Randwick Local Planning Panel (Public) Meeting

Development Application Report No. D36/25

Subject: 30-32 Moore Street, Coogee (DA/351/2025)

Proposal:	Demolition of the existing structures to enable the construction of a 4-storey residential flat building, including 4 units (2 x 3 bedroom, 1 x 2 bedroom, 1 x 1 bedroom), basement car parking with 6 spaces and associated landscaping works.
Ward:	North Ward
Applicant:	Arkivis Pty Ltd
Owner:	Mrs C Panigiris & Mr T Panigiris
Cost of works:	\$3,906,231
Reason for referral:	The development is subject to Chapter 4 of the Housing and more than 10 unique objections were received.

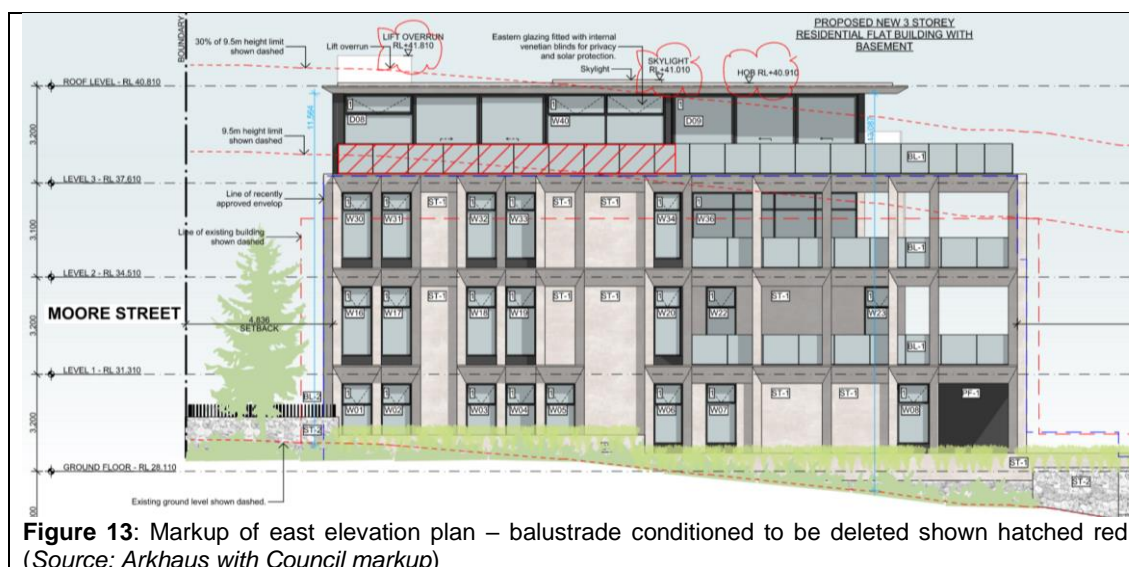
<p>6. <u>Amenity</u></p> <p><i>Privacy to the western neighbour has partially been achieved through obscured glazing to some windows, but this needs to be extended to W42 and 43 on the additional floor. In addition, the applicant needs to address overlooking of the neighbours' balconies from the proposed balconies on Levels 2 and Level 3, whilst retaining neighbours' cross views to Gordons Bay – consider a planter along the western balcony edge for these two levels.</i></p> <p><i>The Pool proposed on Level 3 creates both acoustic and visual privacy problems for the western neighbour. The Panel recommends it to be removed and replaced with planting on both Levels 2 and 3. This planting should extend along the western balcony to the northern balustrade to minimise potential privacy loss to the western neighbour.</i></p>	<p><u>Applicant</u>: In response to the pool concerns, we note that the neighbour's property is largely screened by the roof form. However, we have proposed a 1.7m-high privacy screen along the western edge of the pool, and a planter along the western boundary, to further mitigate any privacy impacts.</p> <p>For W42 and W43, the glazing type remains as currently proposed, with privacy addressed via the 1.7m screen. The updated drawings reflect these changes.</p> <p><u>Council</u>: Refer to detailed discussion at Key Issues section of this report relating to visual privacy. A condition is included to delete the proposed swimming pool and replace with a non-trafficable planter box.</p>

<p><i>Access to the Pool equipment on Level 2 appears to have a constrained head height.</i></p>	<p>units, and is not intended for regular access. The door access complies with the minimum head height clearance of 2.1m.</p> <p>The housing of the pool equipment is 1.7m which is enough for the pool equipment and does not present a functional issue.</p> <p><u>Council:</u> A condition is included to delete the proposed swimming pool and associated equipment area at Level 2.</p>
<p>8. <u>Housing Diversity and Social Interaction</u></p> <p><i>A two-bedroom Affordable Rental Housing unit will be a welcome addition to the area's housing diversity. On such a small site, and with extensive parklands nearby, common open space is not required.</i></p>	<p><u>Applicant:</u> We acknowledged the Panel's comments and support.</p> <p><u>Council:</u> Noted.</p>
<p>9. <u>Aesthetics</u></p> <p><i>1:20 design intent sections are recommended - demonstrating materials, construction systems, balustrade types and fixings, balcony edge treatments, window operation, any integrated planter beds, material junctions, rainwater and balcony drainage systems, and the placement of downpipes or similar elements - for design clarity and to avoid later modifications.</i></p> <p><i>The applicant should consider further investigation whether the extent of glazing within the expression of the top floor needs to be rationalised, to ensure kitchen and bathroom exhausts can be successfully incorporated into the façade design.</i></p> <p><i>Vertical fins appear too thin and need to be drawn in detail. Consider omitting those fins that are not framing windows for a more functional, less material intensive design.</i></p> <p><i>The top level glass balustrades appear excessive, and will be a potential cleaning and maintenance issue – consider a lesser glass balustrade in lieu to the inside face of opening doors to Unit 03 Living room on the eastern elevation.</i></p>	<p><u>Applicant:</u> We understand the importance of design clarity. These matters will be resolved and fully documented at the CC stage. At this DA stage, we believe the level of detail currently provided clearly conveys the intended architectural quality of the proposal. Further technical detailing (e.g. material junctions, drainage systems, glazing coordination, balustrades, and vertical fins) will be addressed in the next design phase.</p> <p><u>Council:</u> The submitted documentation is suitable for DA stage. Noting the concerns regarding excessive glazing at Level 3, a condition is included to delete the proposed balustrade adjoining the eastern edge of the eastern planter box – refer markup at Figure 13 below.</p>

Council's request for information dated 06 June 2025 requested the deletion of the swimming pool, however, the amended plans submitted on 27 June 2025 did not incorporate this request. As such, a condition is included to delete the swimming pool (and associated equipment area below) and replace with a planter box. The balustrade to the west of the pool and the door to the equipment area (at Level 2) shall also be deleted.

Figure 14: Extract of shadow diagram – 3pm midwinter (Source: Arkhaus)

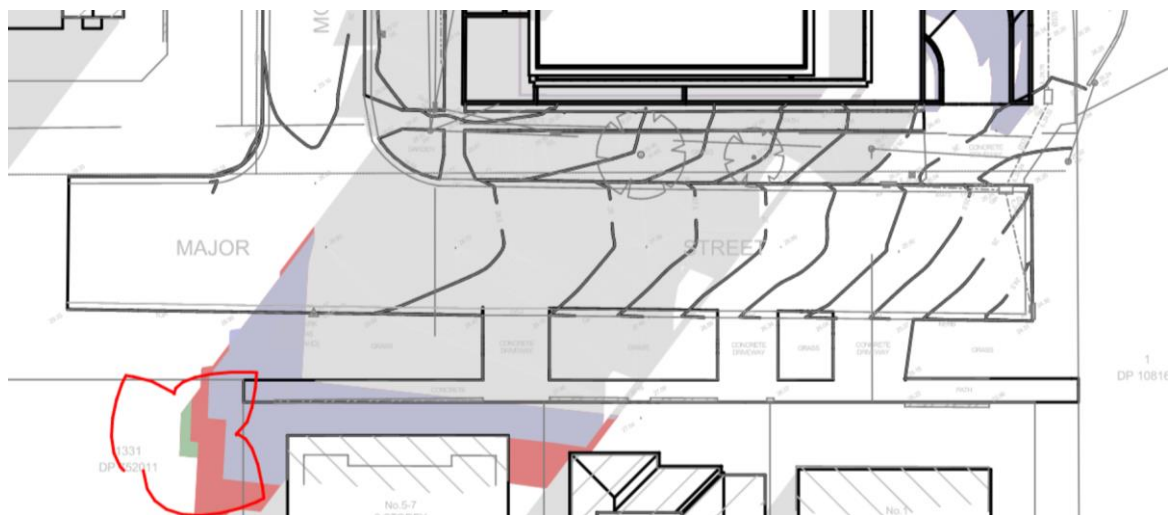
The submitted shadow diagrams demonstrate that suitable solar access will be maintained to the foreshore area, including Dunningham Reserve. Between 10am and 2pm (midwinter), additional shadows (relative to the existing situation) will fall to the road reserve (and footpath) of Moore Street and Major Street only. As shown in Figures 14-15, additional shadows to Dunningham Reserve at 3pm (midwinter) will fall to an area that is not of high scenic or recreational value, being a planted area adjacent to the secondary pathway entrance to the reserve.

In this regard, Council is satisfied that the non-compliant portion of the proposed building does not directly result in any significant adverse overshadowing of Dunningham Reserve.

Figure 17: Height plane diagram (Source: Arkhaus)

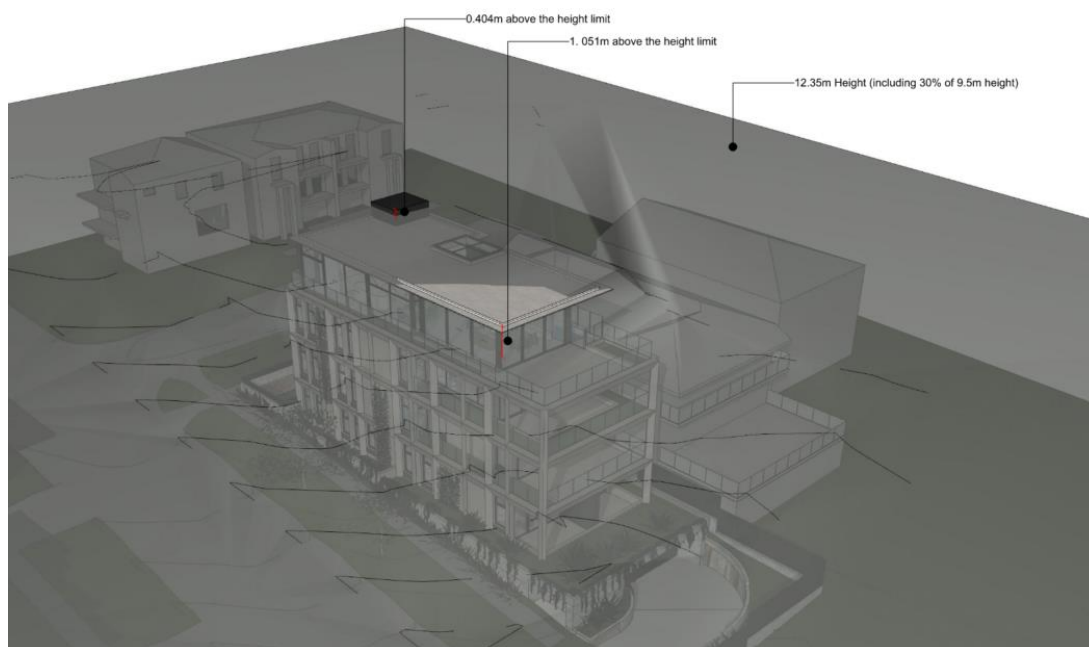
As shown in Figure 17, the non-compliant portion of the proposed building is limited to the lift overrun (0.4m variation) and a portion of the roof form at the north-eastern corner (1.05m variation).

The subject site experiences a considerable fall from the front (south) to the rear (north). It is considered that the height variation can be attributed to the topography of the site. The additional bulk at the rear of the building results from where the land has been excavated to provide a basement level.

The lift overrun is necessary to provide equitable access to the building and is not considered to result in any significant addition impact relative to view loss, overshadowing, visual privacy, or the like.

Figure 18: Sun eye diagram for the proposed development at 11am with Council markings in red showing window areas that receive solar access – 3-4 Llanfoyst Street, Randwick (Source: Orosi)

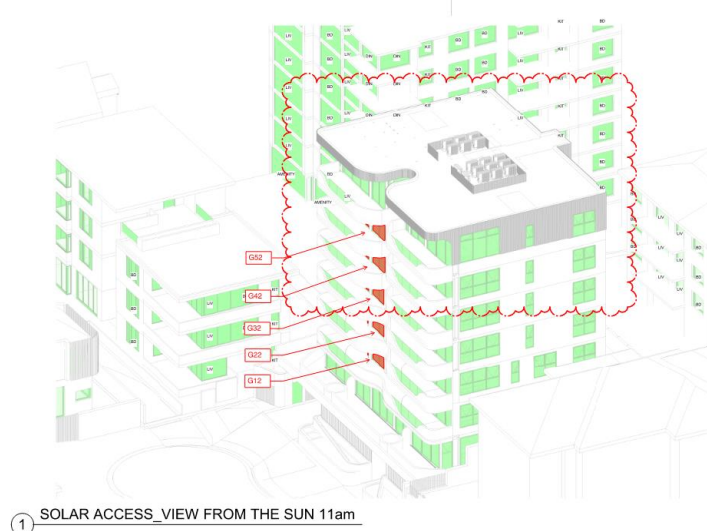
The Applicant asserts that 15 of the 17 dwellings (or 88%) of dwelling living rooms receive 2 hours of direct sunlight. Council asserts that only 10 of 17 dwellings (or 59%) of dwelling living rooms receive 2 hours of direct sunlight, in considering the planning principle for access to sunlight under *The Benevolent Society v Waverley Council* [2010] NSWLEC 1082.

The discrepancy of 5 dwellings accounts includes Dwellings G12, G22, G32, G42, and G52 which Council notes do not receive sufficient solar access to living rooms windows at 11am, and therefore insufficient solar access for 2 hours between 9am-11am. As demonstrated in the plan below, only a small portion of the windows receive solar access. Figure 18 has been reproduced below with Council mark-ups, showing that only a small portion of the glazing receive direct sunlight to the living room windows to Dwellings G12, G22, G32, G42, and G52.
